Subject: Oconee Nuclear Station  
Docket Nos. 50-269, -270, -287  
Response to Request for Additional Information on  
the Oconee Emergency Power System

REQUEST FOR ADDITIONAL INFORMATION  
OCONEE EMERGENCY ELECTRICAL POWER  
DISTRIBUTION SYSTEM

Figure H-6: Test3, Keowee Frequency and V/Hz

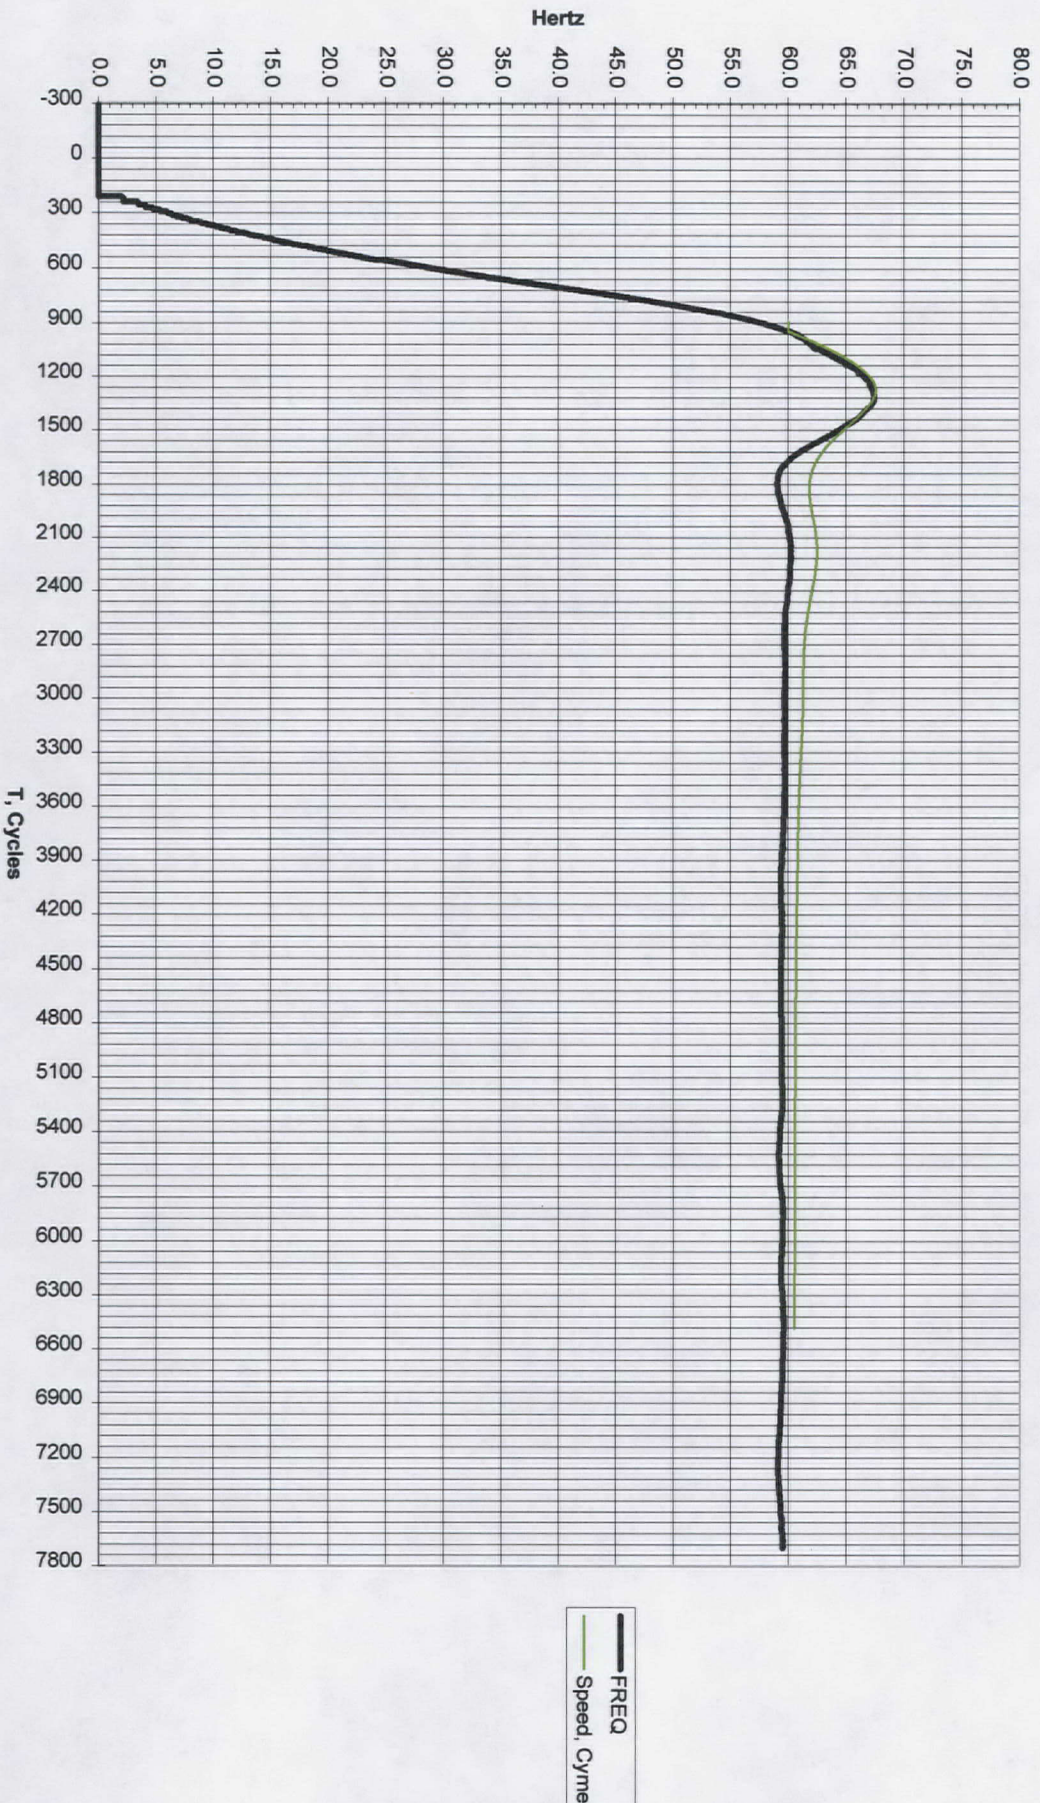
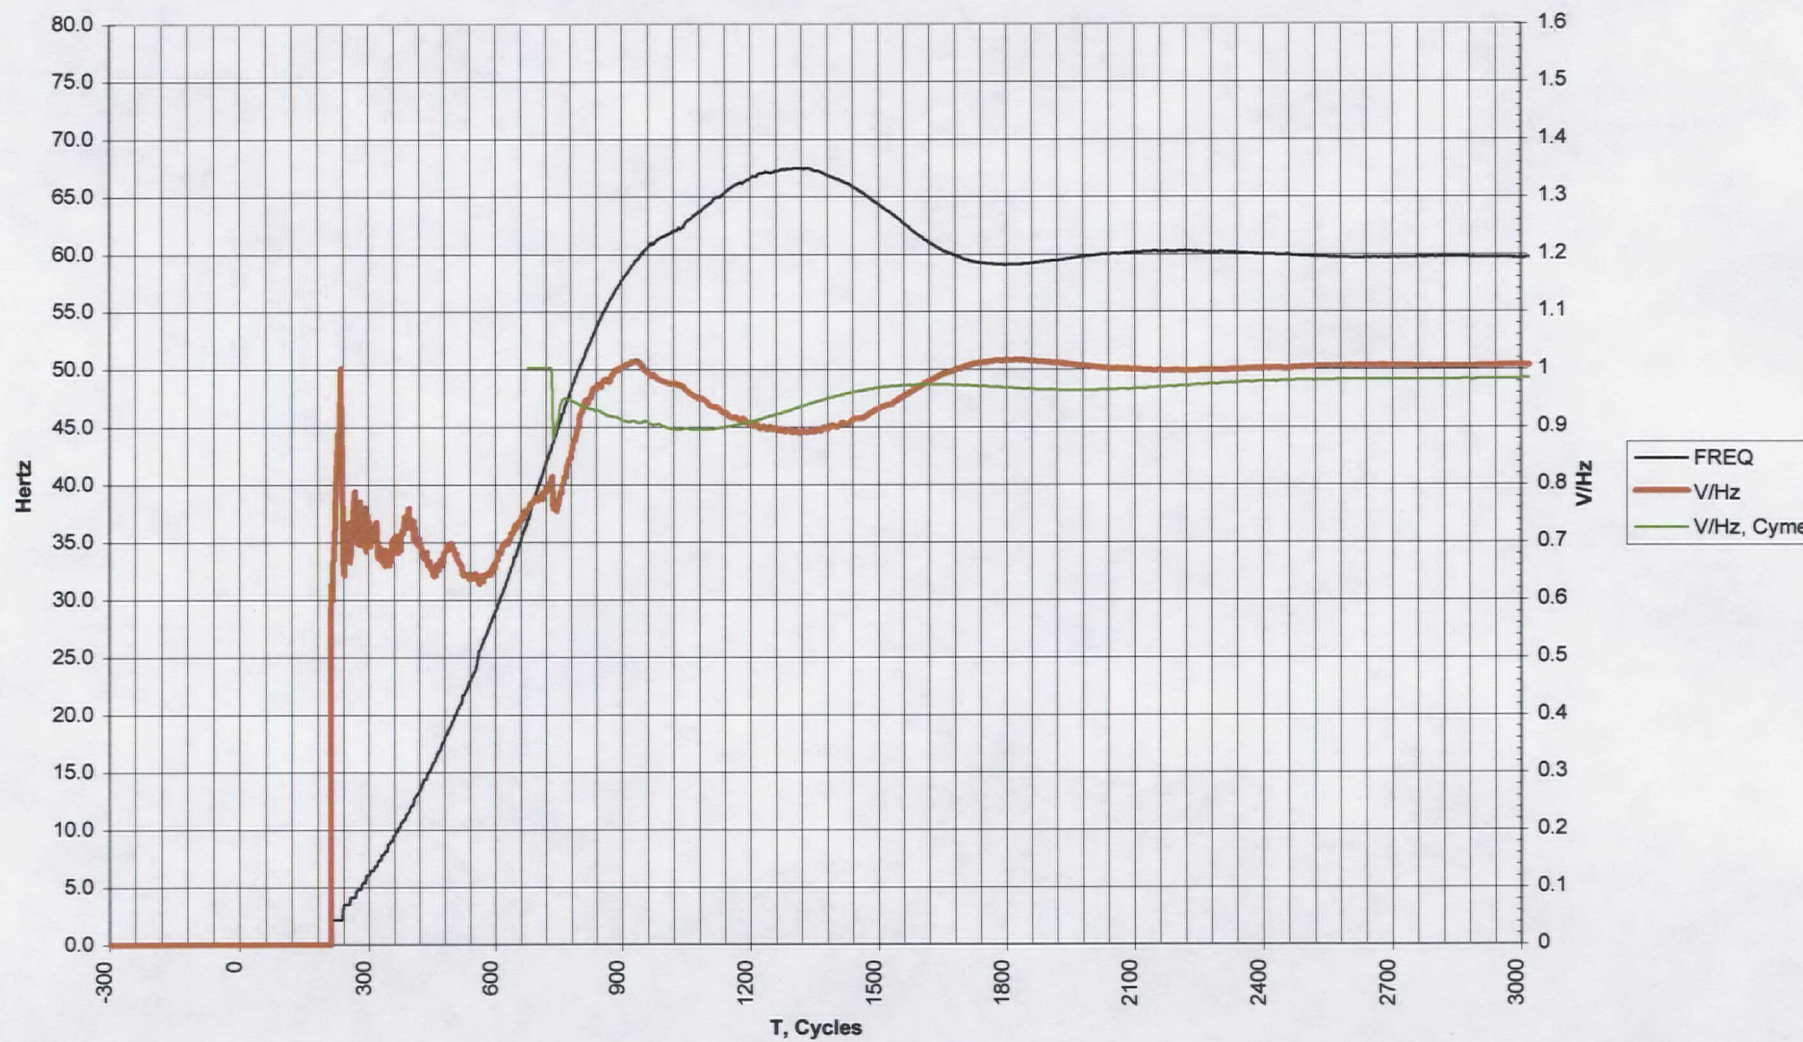
7. The conclusion of the report states that although Test 3 (reduced voltage and frequency starting scenarios) is not included in this report, a comparison of the test data and CYME model predictions show the model to predict conservative results, except for the RBCF B motor.

- a. If the CYME program cannot begin its analysis at a frequency different from 60 Hz, how was the program used to make this prediction?

Although the CYME program cannot directly be used to perform analyses with the Keowee unit starting from standby, it is used to predict the response of the Oconee loads indirectly. An analysis/comparison was performed for Test 3 assuming a small load rejection which gave an overspeed response similar to that seen during Test 3. Loading was applied in the model at load rejection. Since in the model loads will be starting entirely during the overspeed, the model will be conservative relative to the actual start from standby (i.e., rotating equipment load torque varies approximately as the square of the frequency and motor torque capability varies

approximately inversely with the square of the frequency). Figures H-1 through H-6 in Attachment 8 are a comparison of the model response and the Test 3 response. Similar comparisons of motor acceleration times indicate conservative motor start times (except for the RBCF which requires an adjustment for reverse rotation as previously identified in the report).

Validation of CYME Model to Test Results

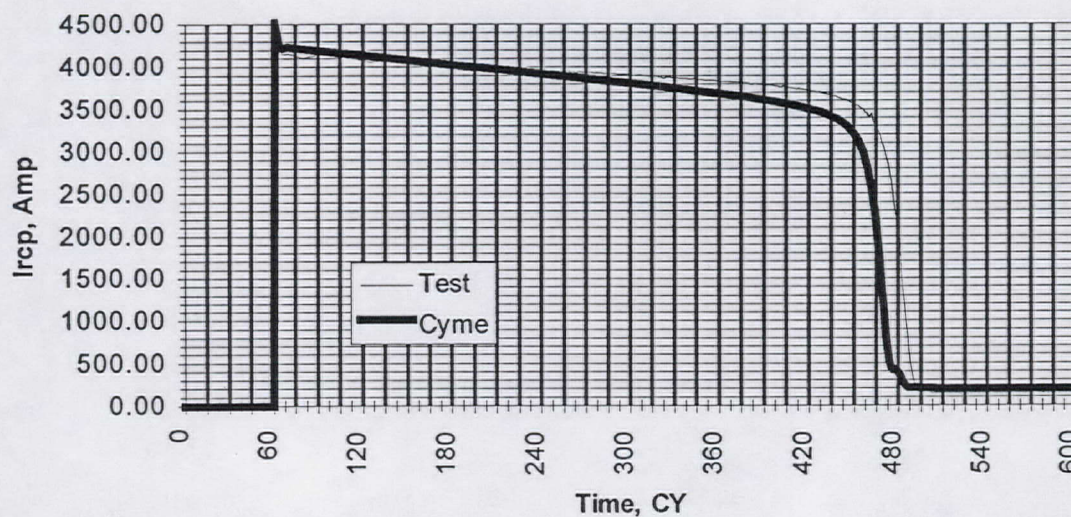
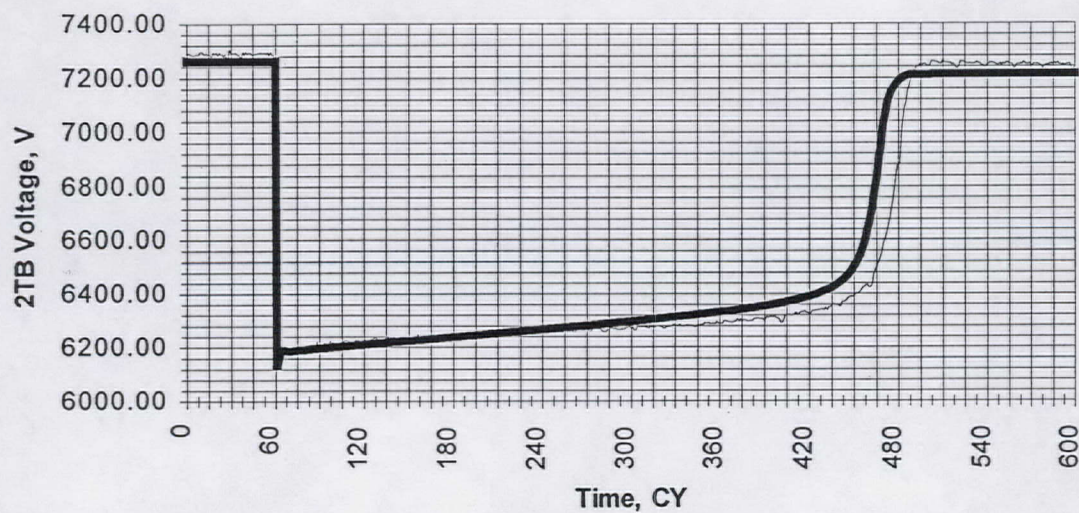
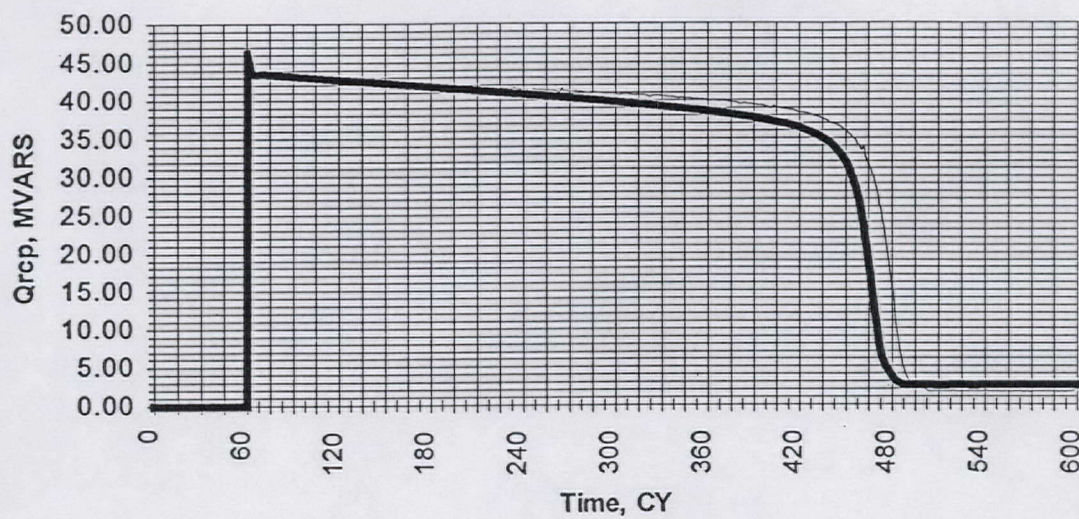
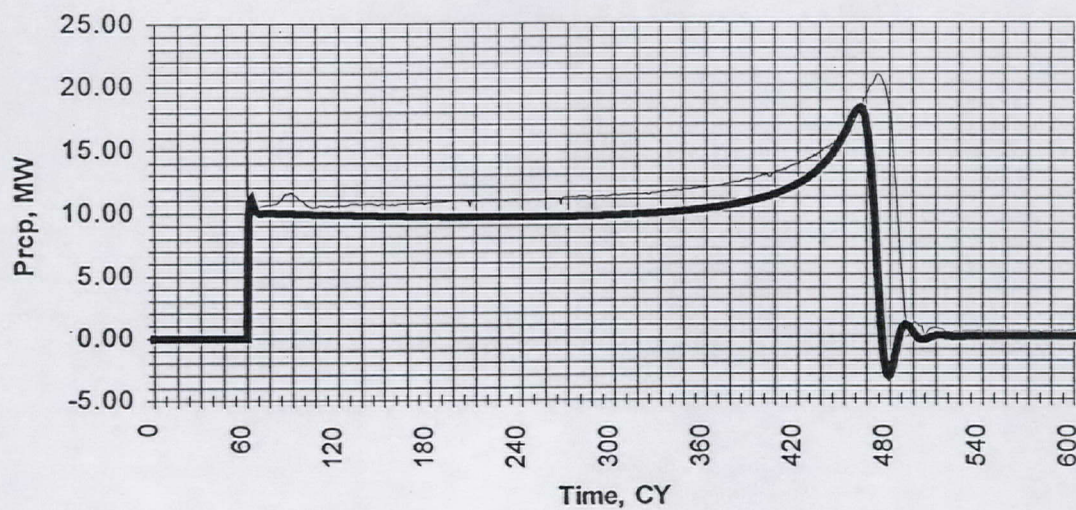
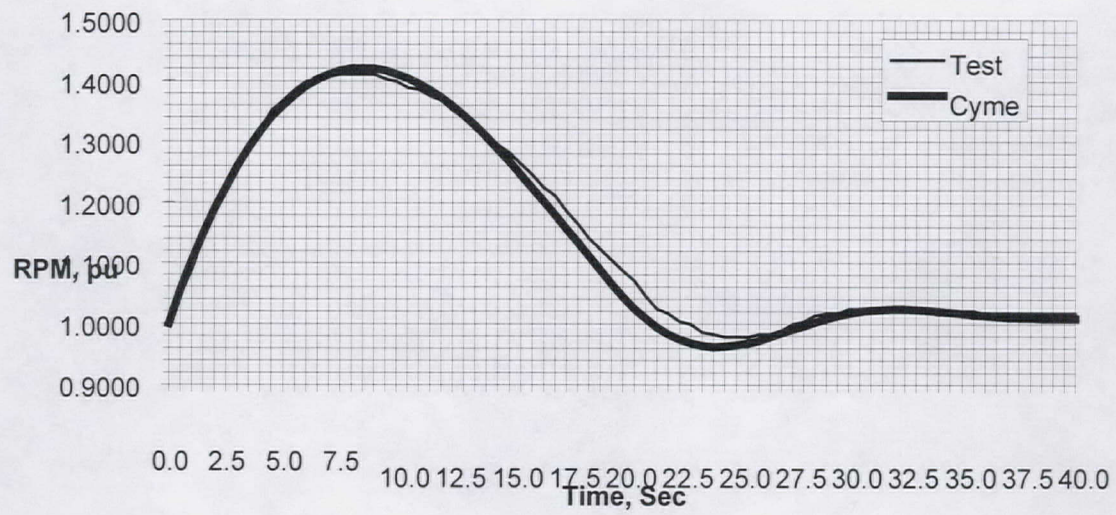
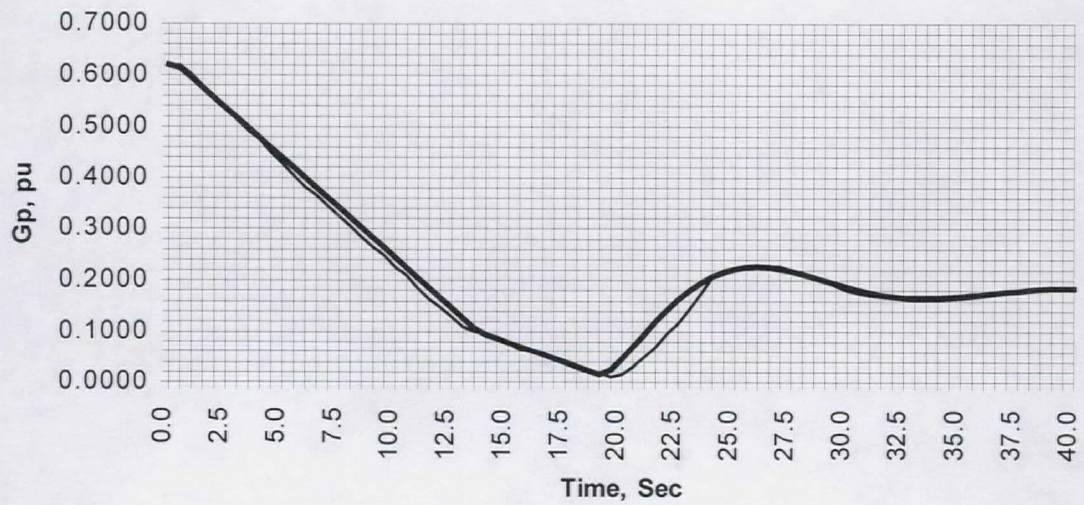
- d. Will a test be performed to validate the CYME Keowee frequency response model for a Keowee full load, two-unit load rejection, or has one already been done? If one has been done, please provide the comparison of the test to the model.

The governor response has been validated using a single unit full load rejection test and reactor coolant pump test. A copy of the comparison of the test to the model is contained in Attachment 9. On a one unit or two unit full load rejection, the relay scheme presently in place at Oconee prevents loading until voltage and frequency have decreased below 110 percent. Test 2 shows that for a single load rejection, loading actually occurs near 60 hertz on the overhead path and Test 5 shows that loading actually occurs around 64.7 hertz on the underground path. With a two unit load rejection, the relaying will function in the same manner as a single load rejection. On a two unit load rejection, the overspeed will be slightly higher than a single unit load rejection, which will result in loading slightly later in time. For both cases, when the relay scheme permits loading, the frequency will be essentially the same and decaying at essentially the same rate. Thus, there will not be any significant difference in the Oconee auxiliary system load response for a single or two unit load rejection.

V/Hz Ratio Plots for Motor Control Center 3XS1

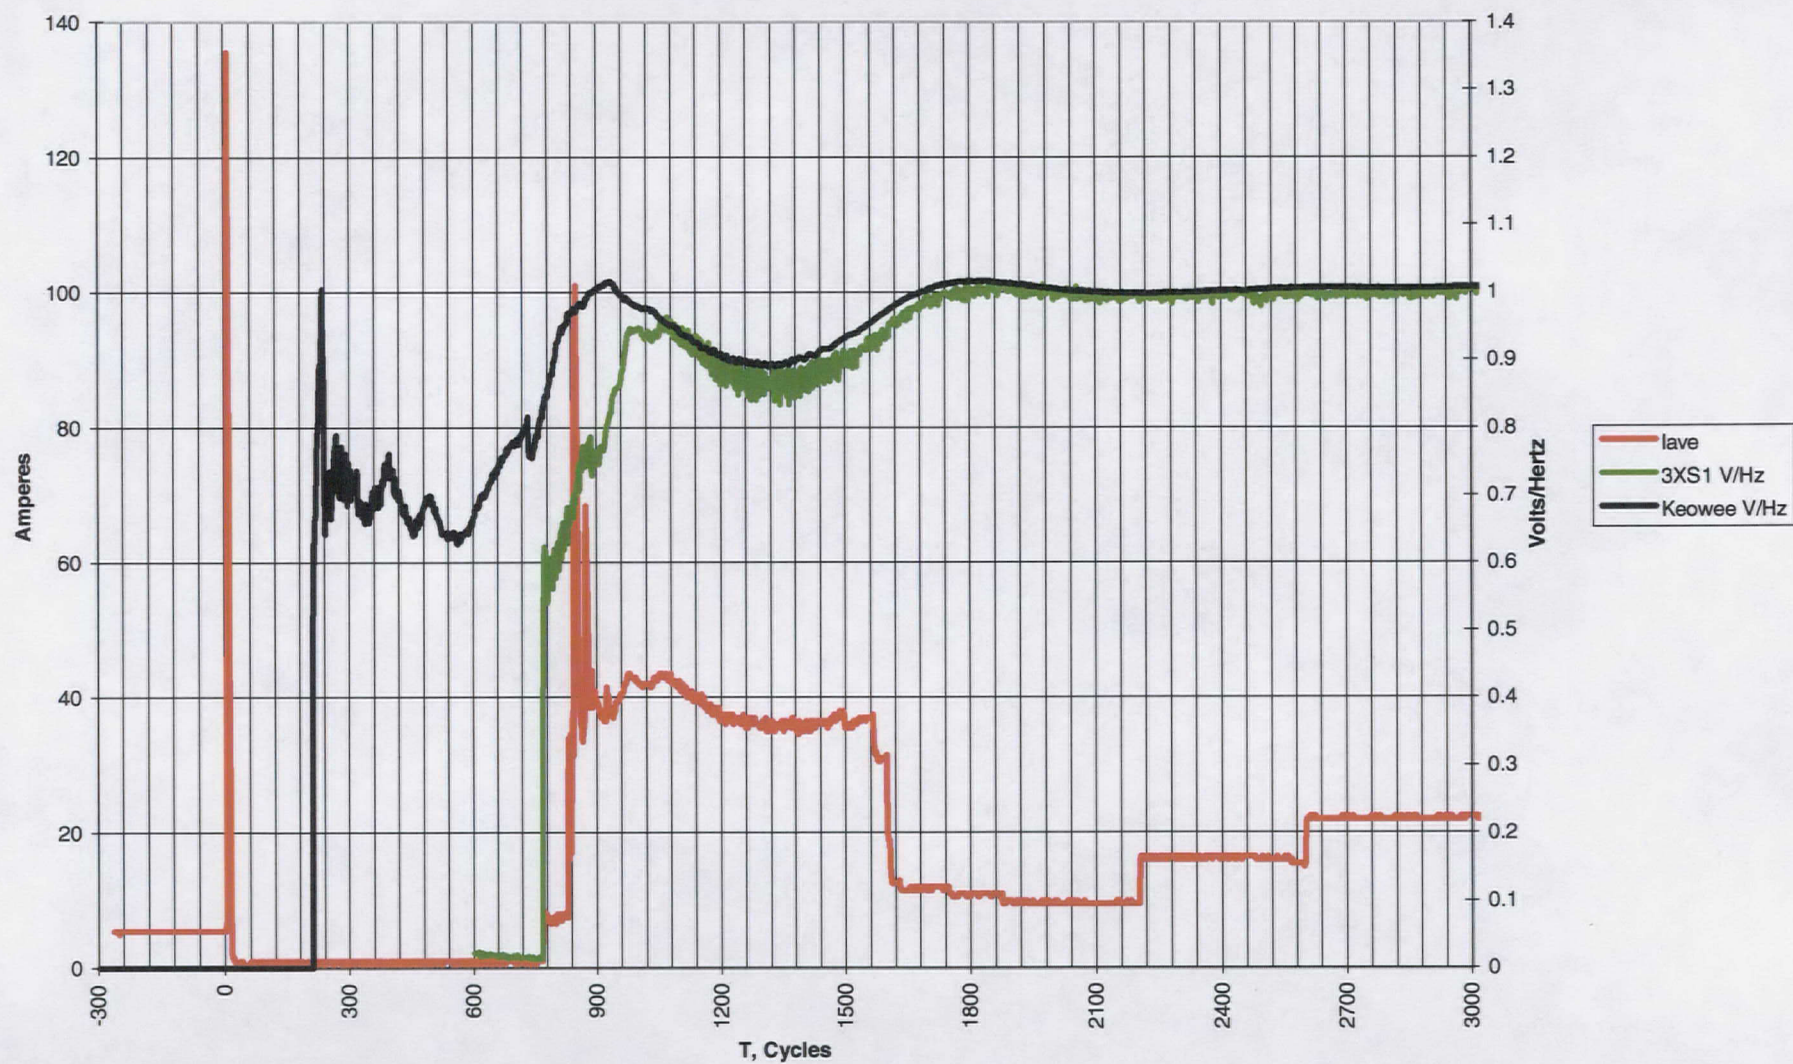
- a. Although the Oconee loads were successfully loaded during the test, explain how successful loading of the Keowee loads can be assured given such a low (76 percent) initial V/Hz ratio.

A comparison of V/Hz ratios on 208VAC motor control center (MCC) 3XS1 for Tests 3 (Standby Start) and Test 4 (Load Rejection Start) is included in Attachment 10. During the

standby start (Test 3), the MCC V/Hz ratio was approximately 0.7 pu when the MCC loads started. During the load rejection start (Test 4), the MCC V/Hz ratio was approximately 0.65 pu when the MCC loads started. Thus, from a MCC V/Hz ratio perspective, the load rejection start was more conservative than the standby start test, even with the field flash breaker cycling problem. Since the load rejection start is more conservative from a V/Hz ratio perspective at the motor control center and can be modeled in the CYME analysis, there is considerable assurance that the loads will start as designed during the standby start scenario.
